SUBJECT: Provides responses to RAIs re plant license renewal project
 for OLRP-1001 license renewal technical info topical rept.
 Draft program description provided in Attachment 3 provided
 as example to begin discussions.

Subject: Oconee Nuclear Station
Docket Nos. 50-269, -270, -287
(TAC Nos. M99121, M99122, M99123, M99141)

ATTACHMENT 1
Oconee License Renewal Project
OLRP-1001 License Renewal Technical Information Topical Report
Responses to NRC Requests for Additional Information
NRC Letter Dated November 14, 1997

Figure 1

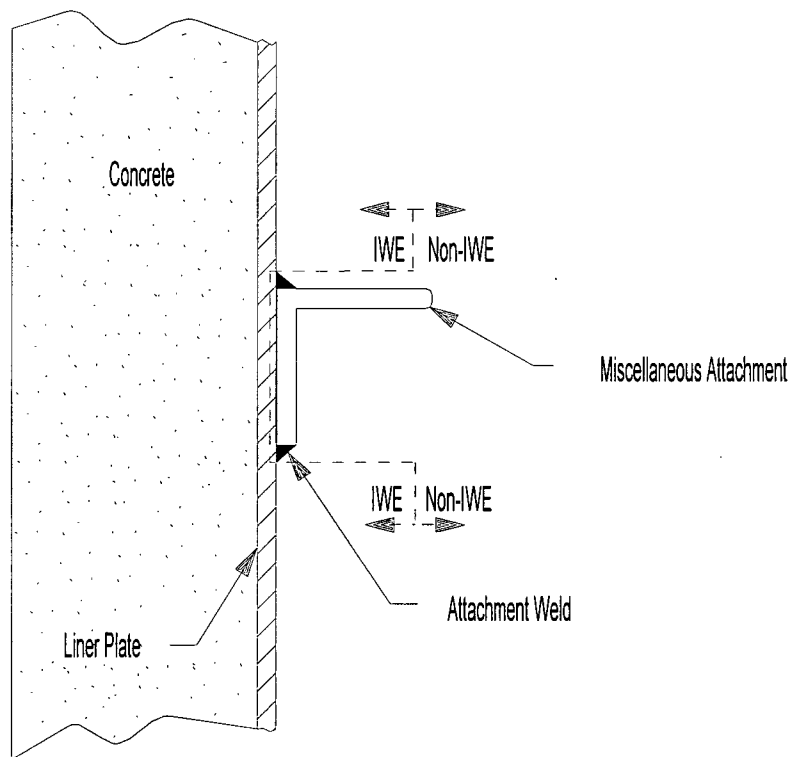
2.3-4	Please provide a discussion regarding "miscellaneous attachments to the liner" as stated in Section 2.3.2.2 of the report. Also provide a figure showing some typical details and the "evaluation boundary."	Miscellaneous attachments to the liner include pipe supports, cable tray supports, HVAC supports, and electrical component enclosures. The evaluation boundary for the Oconee Containment review excludes welds between the miscellaneous attachment and the liner. This boundary is consistent with the inspection requirements contained in ASME Section XI Examination Category E-A, <i>Containment Surfaces</i> , (Footnote 5) of Subsection IWE. Please see Figure 1 at the end of Attachment 1.	No changes to OLRP-1001 are required.
